APPEAL SUMMARY

| Appeal ID: 27518 | Project Address: 3031 SE Hawthorne Blvd |
| Building/Business Name: 31st and Hawthorne | Fire Sprinklers: Yes - NFP13 throughout |
| Appeal Involves: Erection of a new structure | LUR or Permit Application No.: 21-105873-CO |

LEVEL 01 - FLOOR PLAN

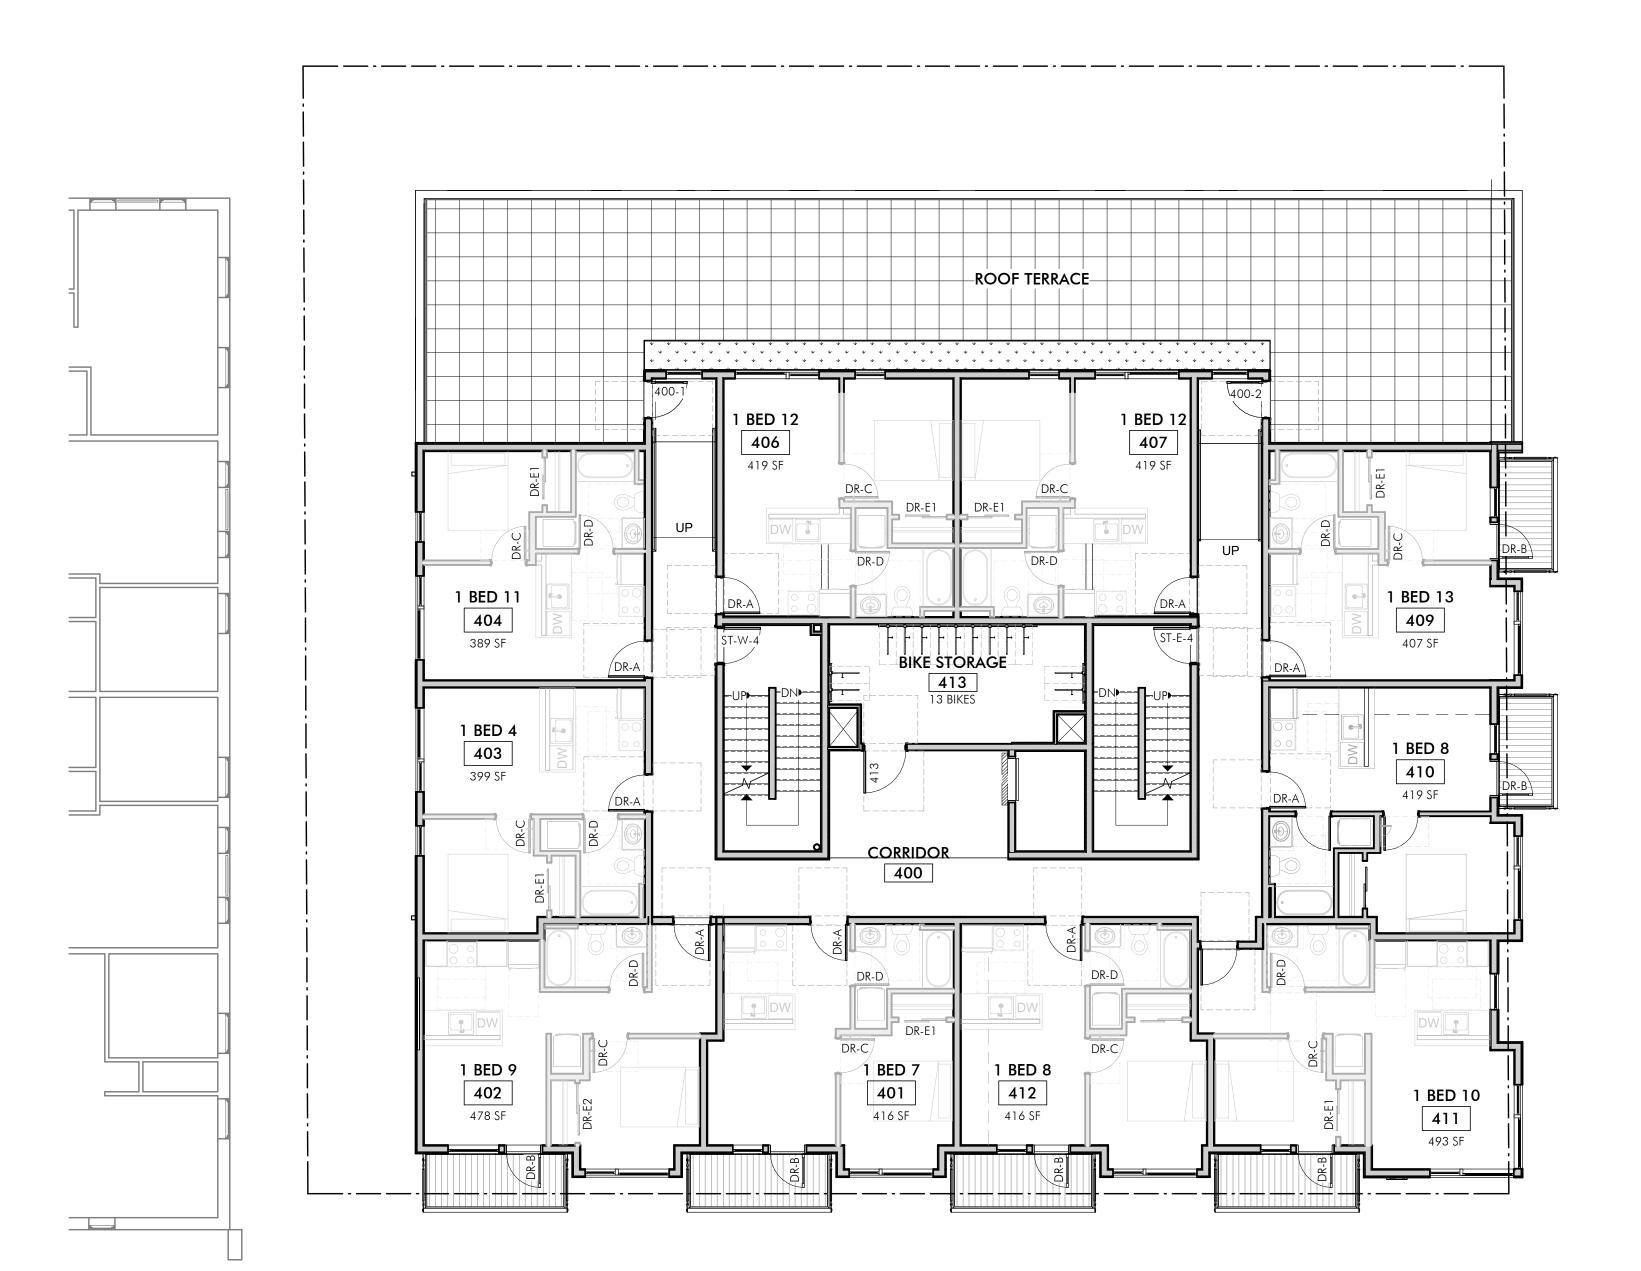
We request clarification/confirmation that locating the area of refuge within an exit passageway meets the intent of this Code section.

The proposed building is a 5 story over basement Type IIIB multi-family structure with 63 dwelling units. Due to the slope of the adjacent sidewalk, one of the required accessible means of egress from the ground floor has a short exterior stair to reach sidewalk grade. Per the Code, providing an Area of Refuge is one way to satisfy the requirement for this accessible exit. We propose to locate this area within the exit passageway, which connects directly to the ground floor corridor system and one of the interior exit stairs from the exterior of the building. The exit passageway walls and floor-ceiling assemblies above and below are all 2-hour rated and meet the minimum requirement for smoke barriers.

Reason for alternative One of the exceptions for separation of Areas of Refuge is to locate within an exit stairway, however, the Code is silent on exit passageways. The proposed exiting configuration and location of the Area of Refuge is consistent with the intent of the Code. Providing a separate room, while still maintaining direct access to the stairway, is not feasible, and would likely be less convenient for use in an emergency situation.

We request that a secondary egress door from an electrical equipment room be allowed to open into an exit passageway.

The proposed building is a 5 story over basement Type IIIB multi-family structure with 63 dwelling units. Due to PGE requirements for size, location, and clearances on electrical service gear and meters, a large electrical room is provided on the ground floor adjacent to an exit passageway. Access to this room is via an exterior door, however, a second exit is required per PGE guidelines. This second exit is proposed to be via the adjacent exit passageway. This door will be used for egress only and will not be operable from inside the exit passageway. The swing of the door will not reduce the required width of the exit path more than as described in the Code. The door will be 90-minute rated as it is within the 2-hour wall of the exit passageway.

Reason for alternative PGE guidelines for providing power to the building dictate that we reserve considerable space for gear and meters and, if located within the building, is provided with a second exit with panic hardware. Zoning Code requirements for electrical gear screening, along with general site constraints, preclude placing the gear/meters on the exterior face of the building. This second door will not be used for access to the room, effectively eliminating the reason why the Code specifically prohibits such openings.

- 2. Location on an area of refuge within an exit passageway: Granted provided all requirements for an area of rescue assistance are verified at time of plan review.
- 3. Location of a secondary egress door from an electrical equipment room be allowed to open into an exit passageway: Hold for additional information.

LEVEL 04 - FLOOR PLAN

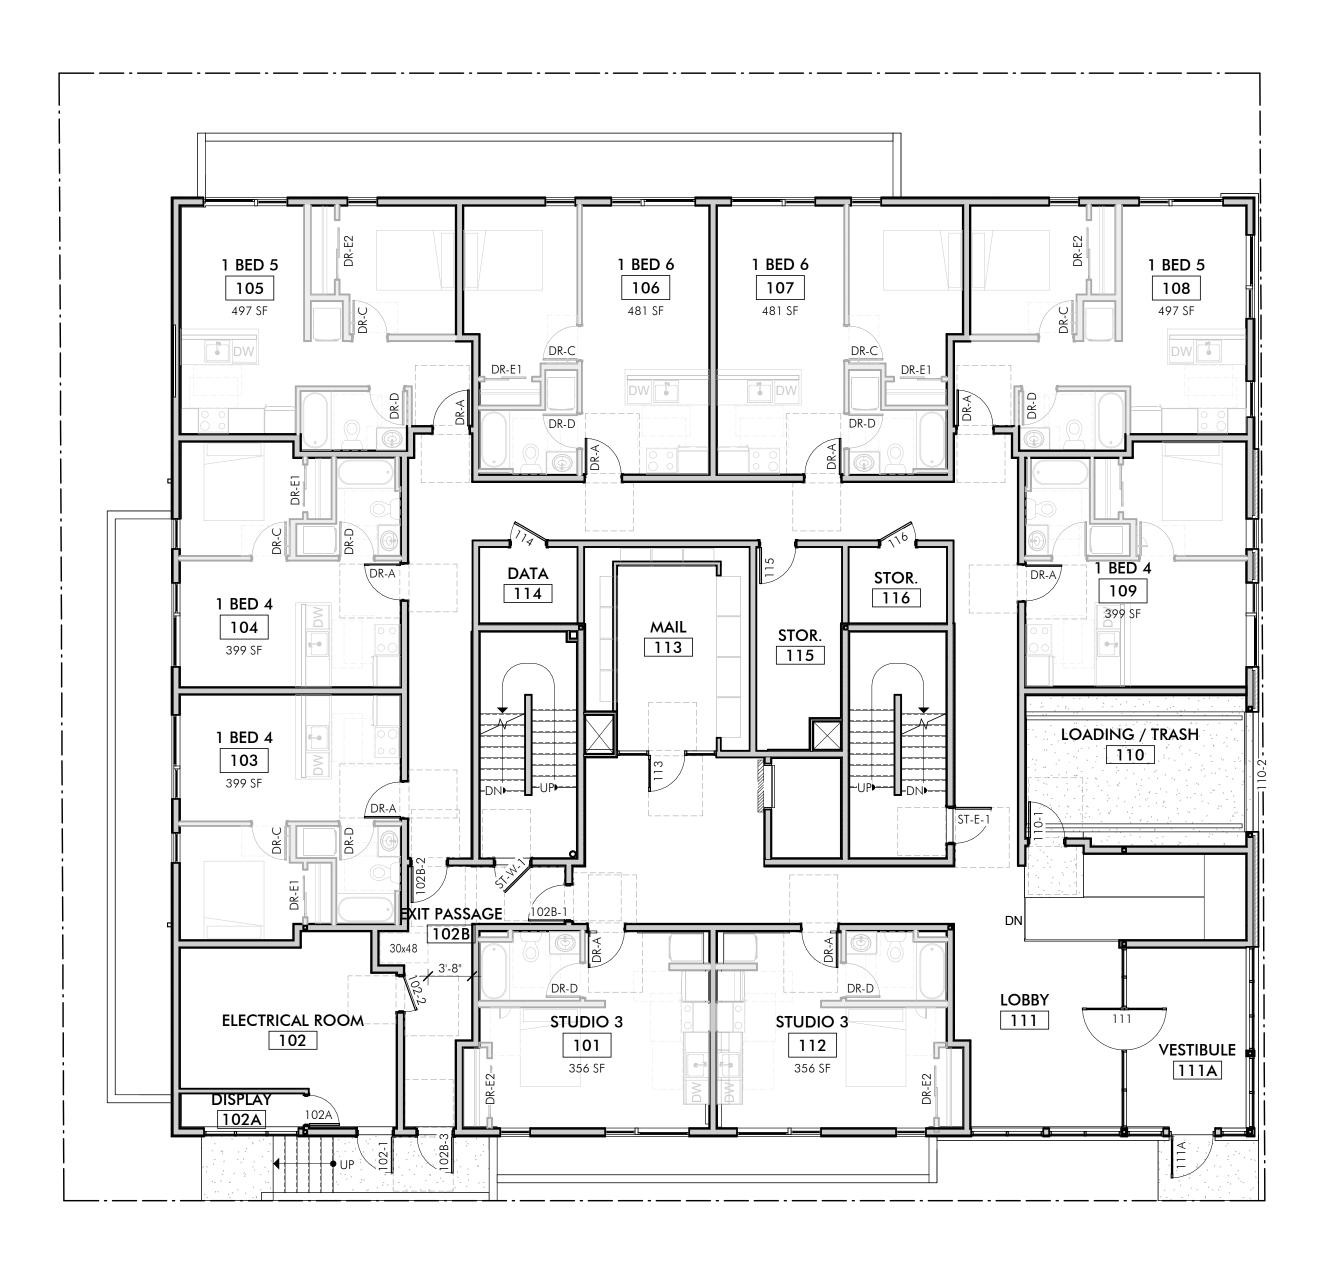
Code Modification or We request exemption from requiring plumbing facilities for an occupied roof terrace. **Alternate Requested**

units. An outdoor roof terrace on level 4 is provided for residents and their guests only. The roof terrace is approximately 1,571 SF and, with a factor of 15 SF per occupant, would have up to 104 occupants. However, as the terrace is only available for use by residential tenants and their

Reason for alternative The roof terrace is provided for use by tenants and their guests and are not open to the public.

The terrace provides outdoor area required by the Zoning Code without sacrificing buildable land or residential density on the lot, furthering the City's development goals. Since the occupants of the terrace would all have close access to facilities within their residential units, we ask to be

1. Occupied roof terrace with omission of minimum number of required plumbing fixtures: Denied. Proposal does not provide equivalent sanitary protection.
